ARDEN SENIOR LIVING CENTER

SITE DEVELOPMENT PLAN

ARDEN SENIOR LIVING CENTER
SITE DEVELOPMENT PLAN
ROLESVILLE, NORTH CAROLINA

SITE PLAN AREA "A"

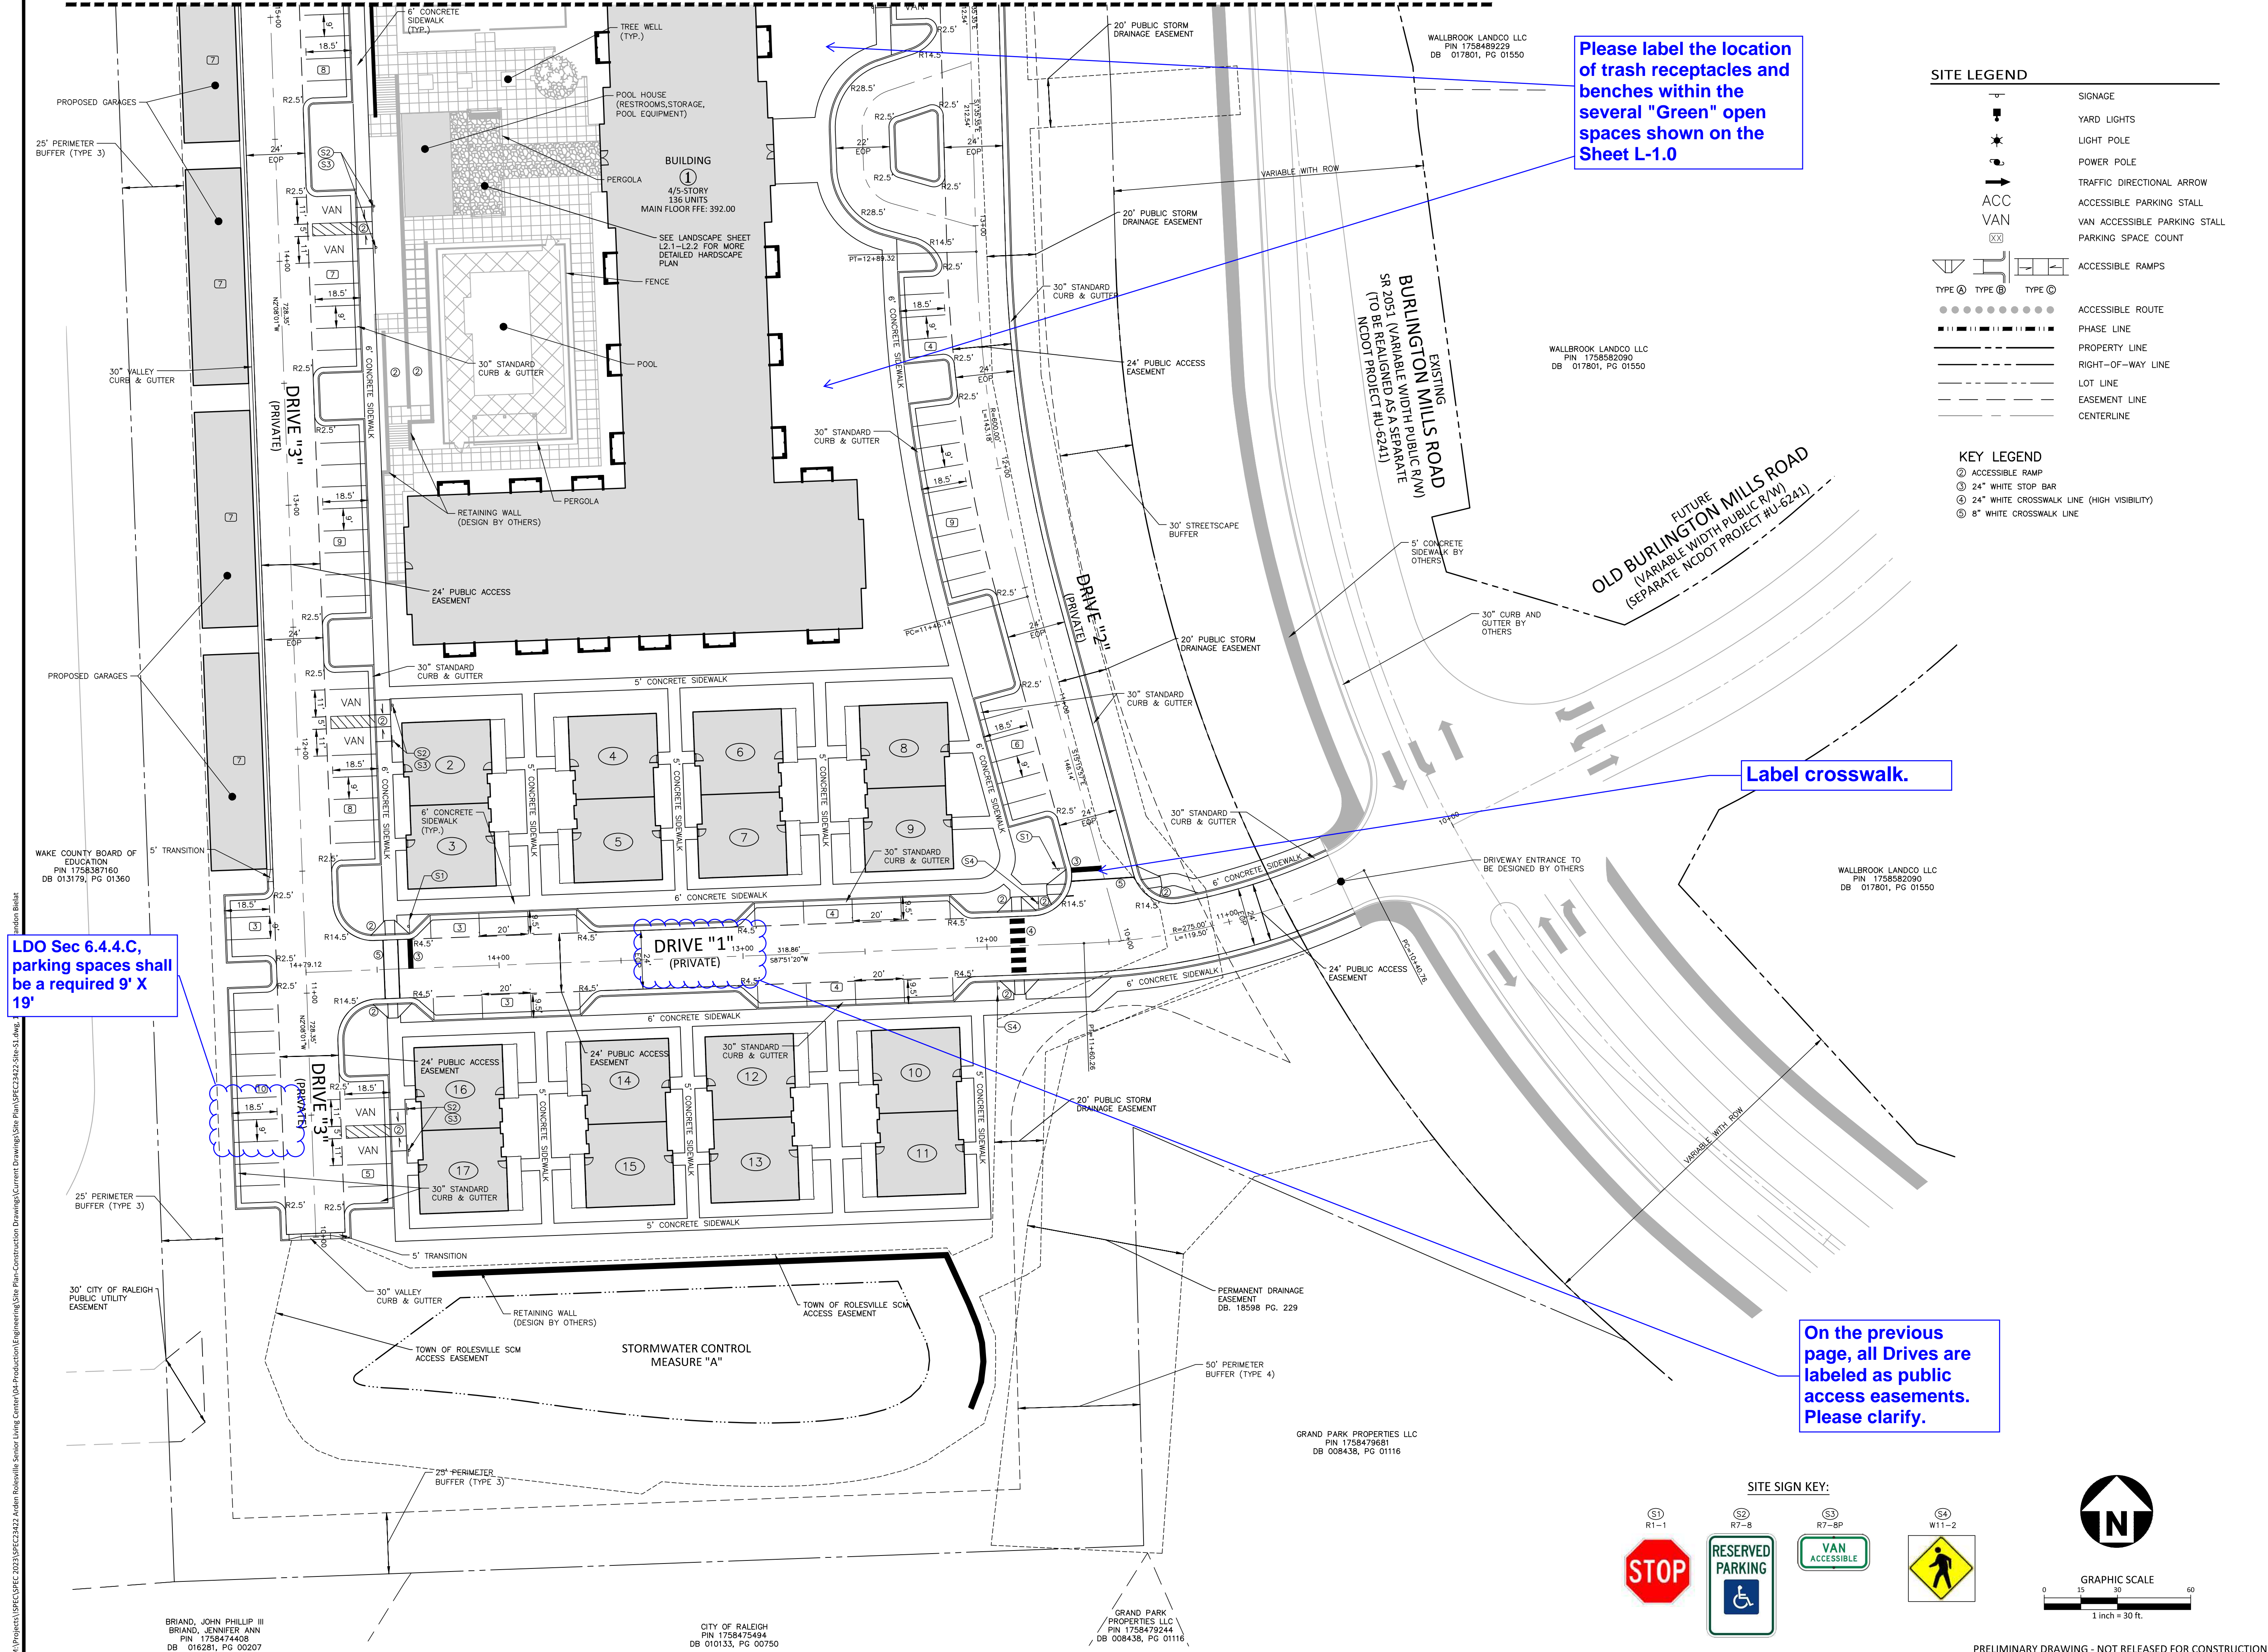
Please label the location of trash receptacles and benches within the several "Green" open spaces shown on the Sheet L-1.0

On the previous page, all Drives are labeled as public access easements. Please clarify.

SITE PLAN AREA "B"

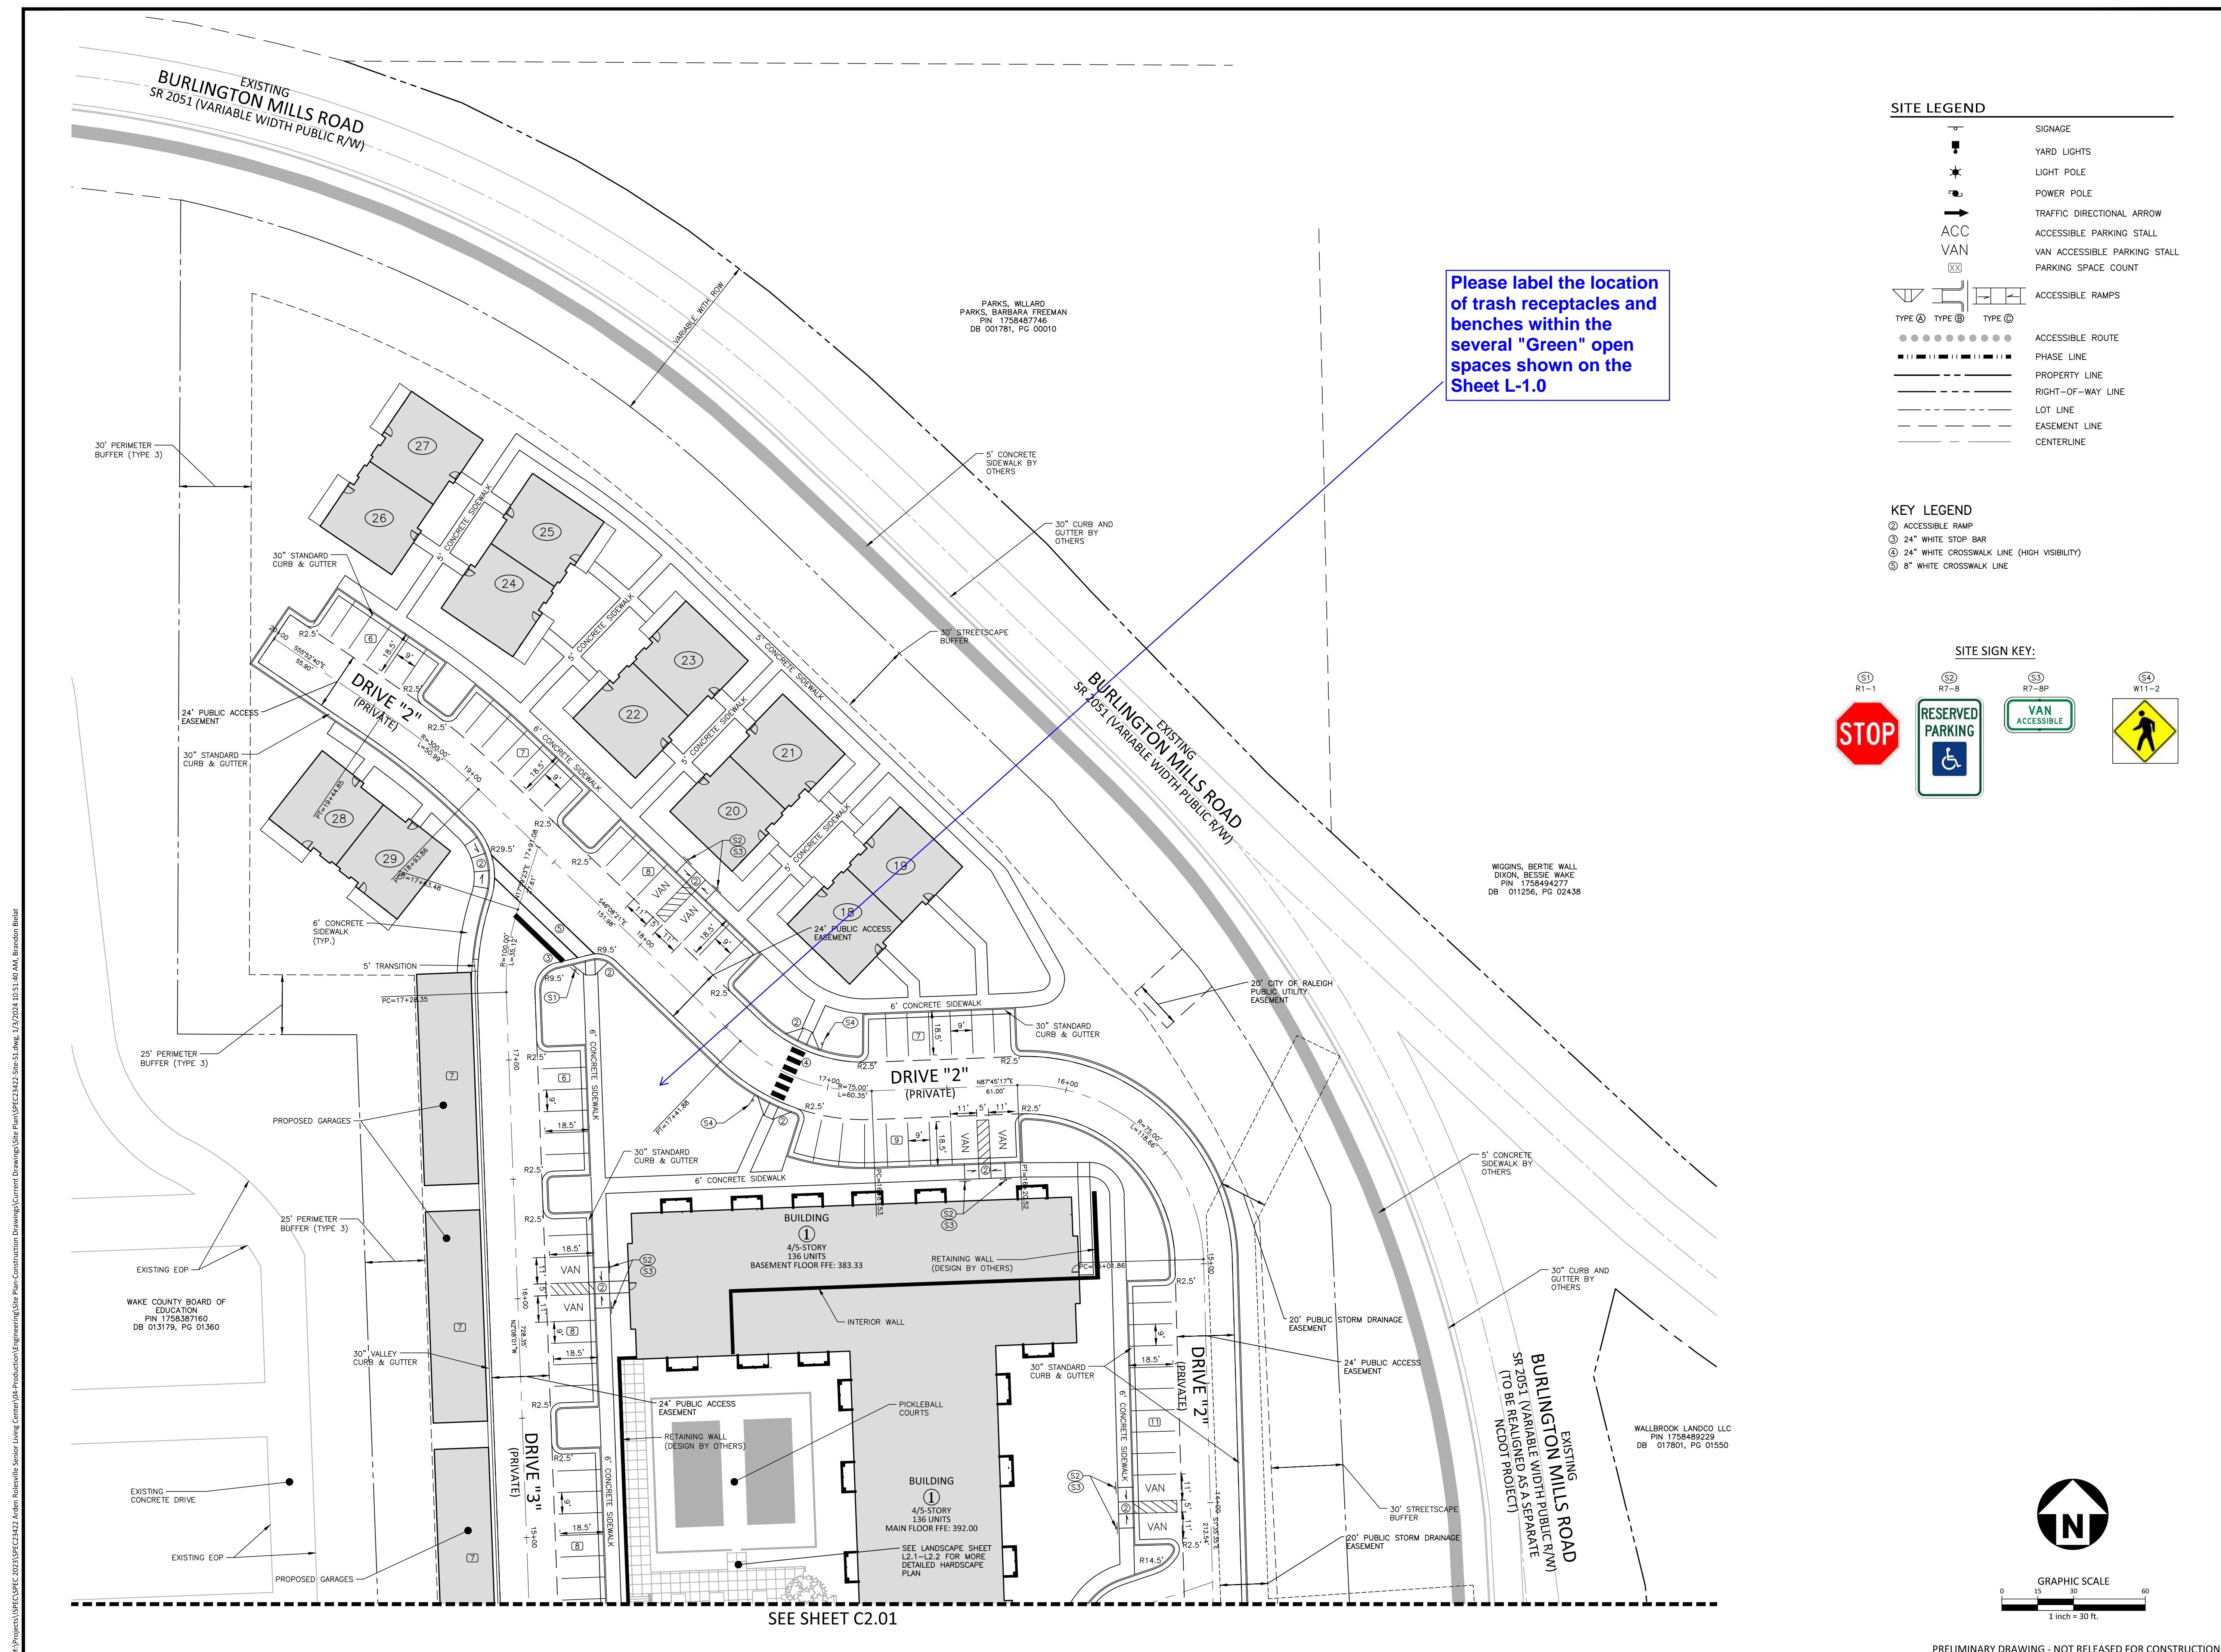
Please label the location of trash receptacles and benches within the several "Green" open spaces shown on the Sheet L-1.0

GRADING AND STORM DRAINAGE PLAN - AREA "B"

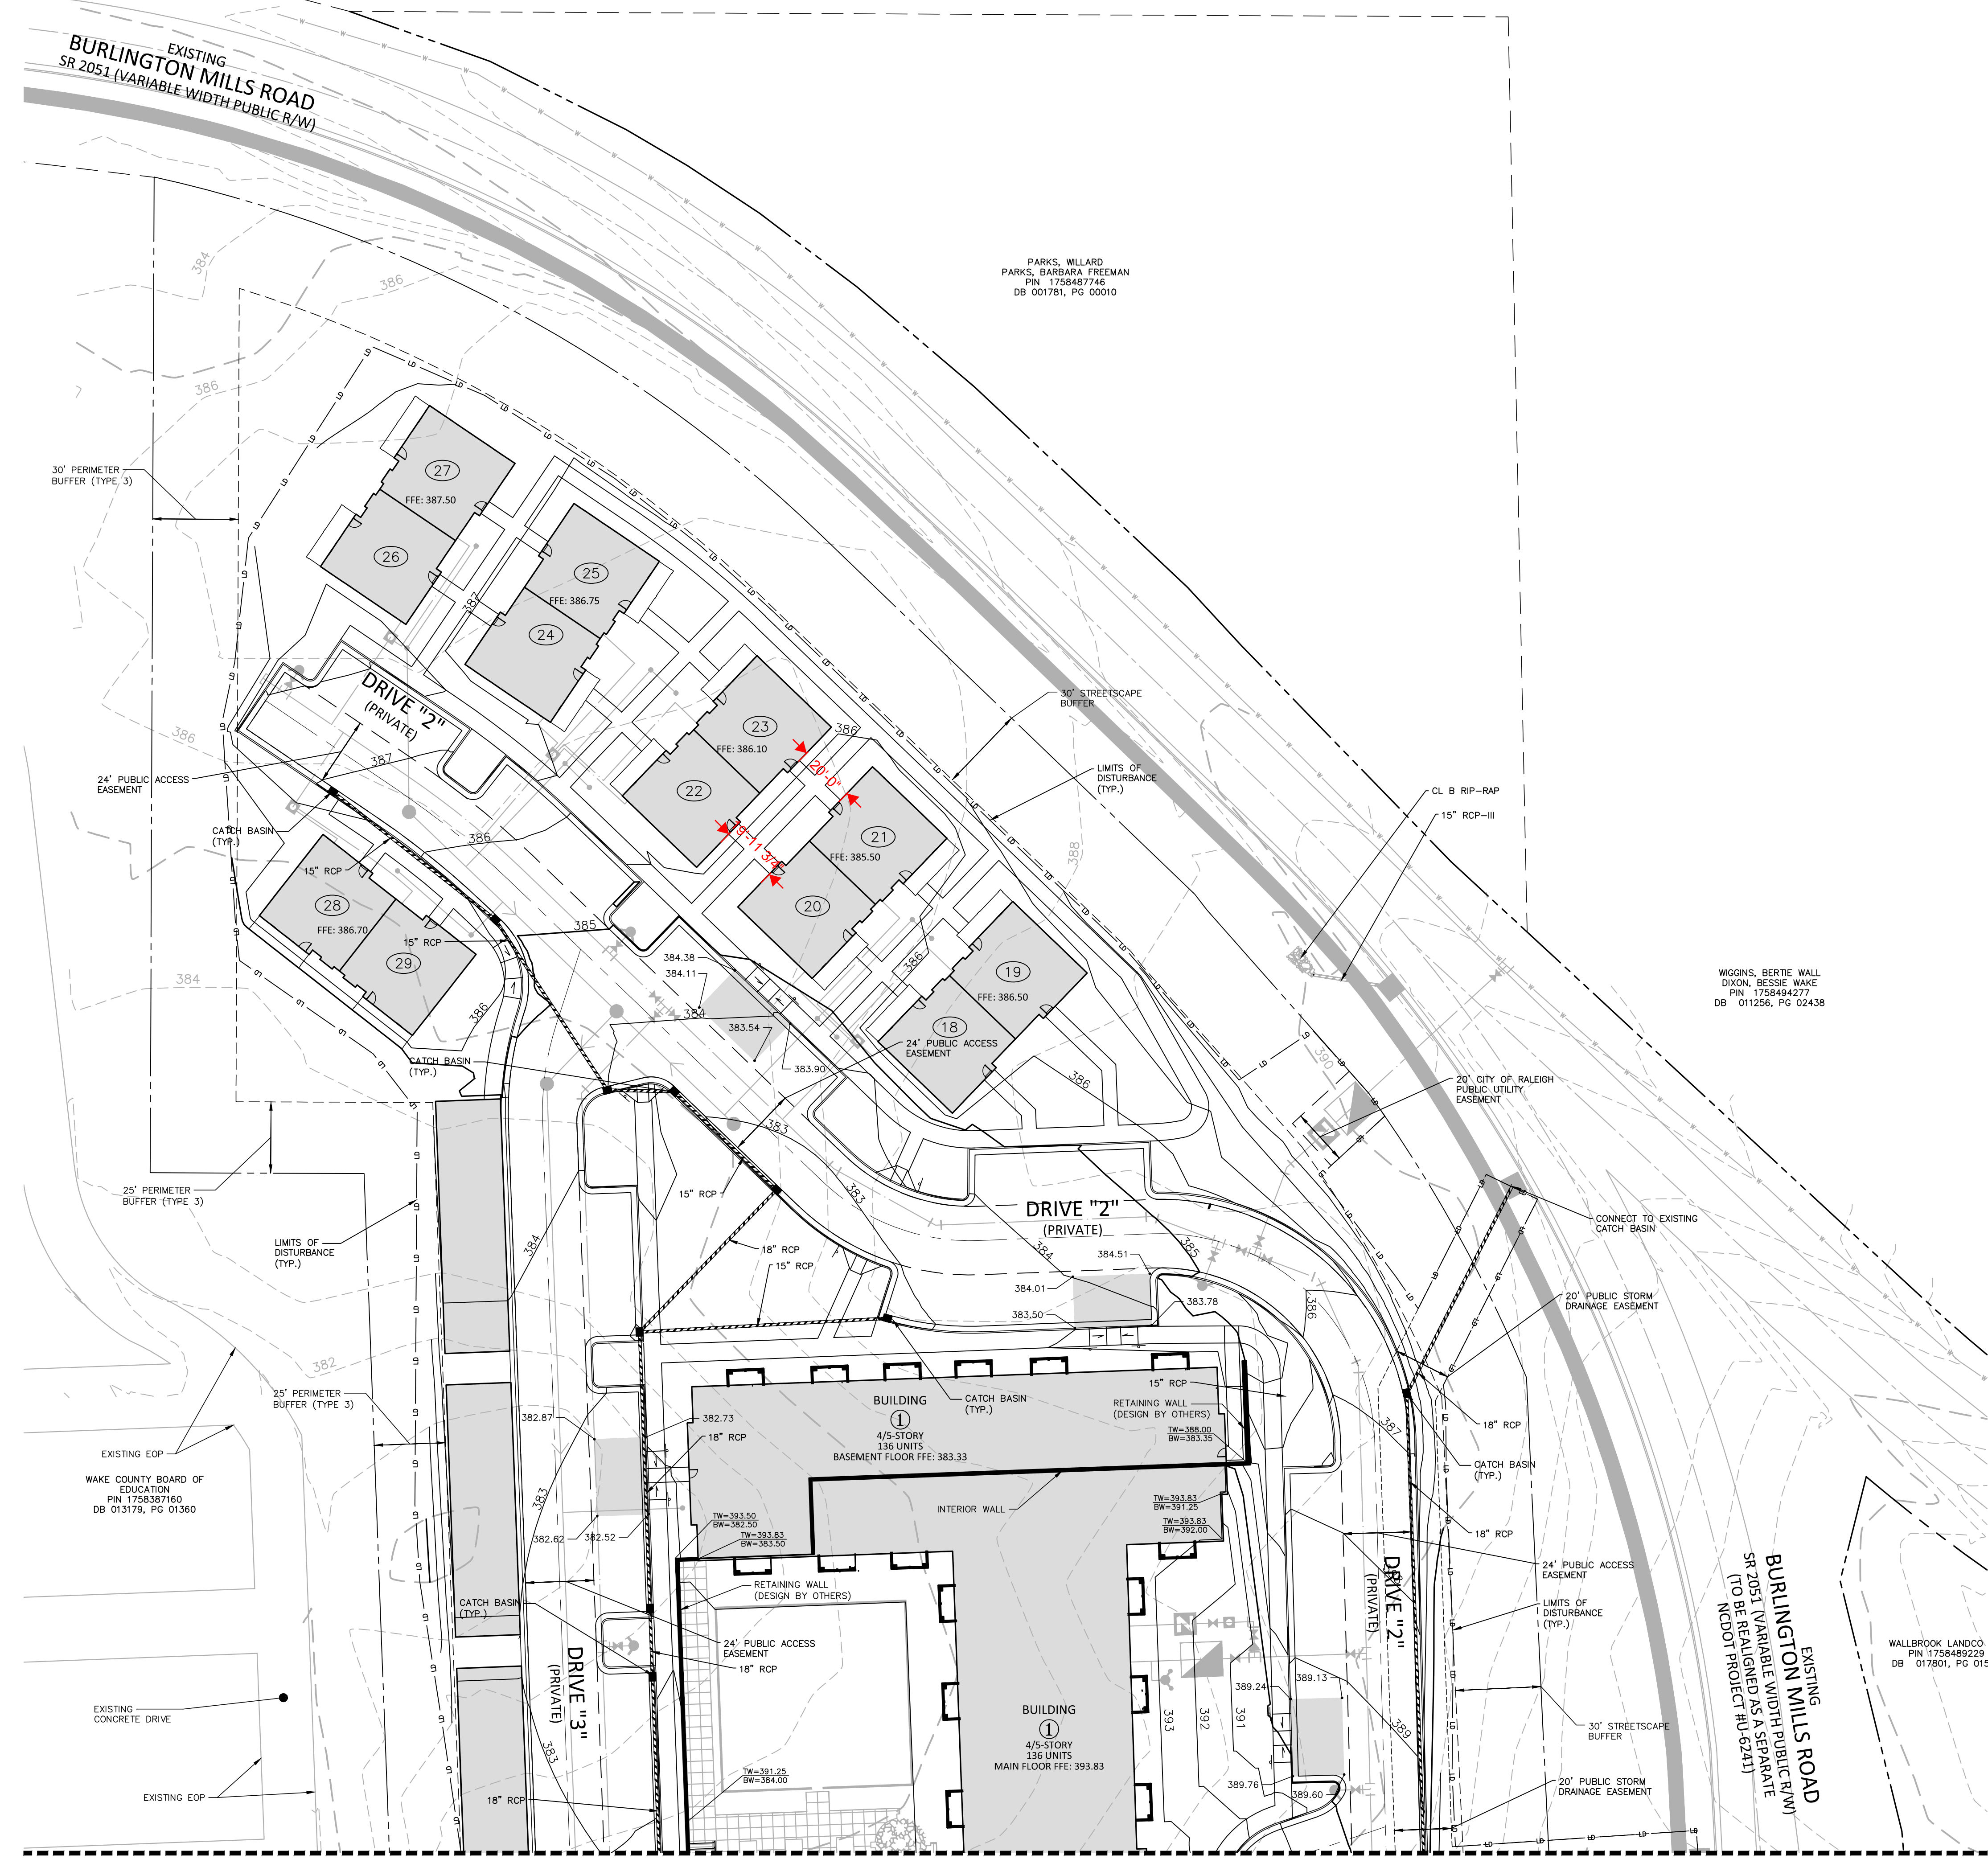
Label the location of all existing landscaping to be preserved as well as the TPF and CRZ.
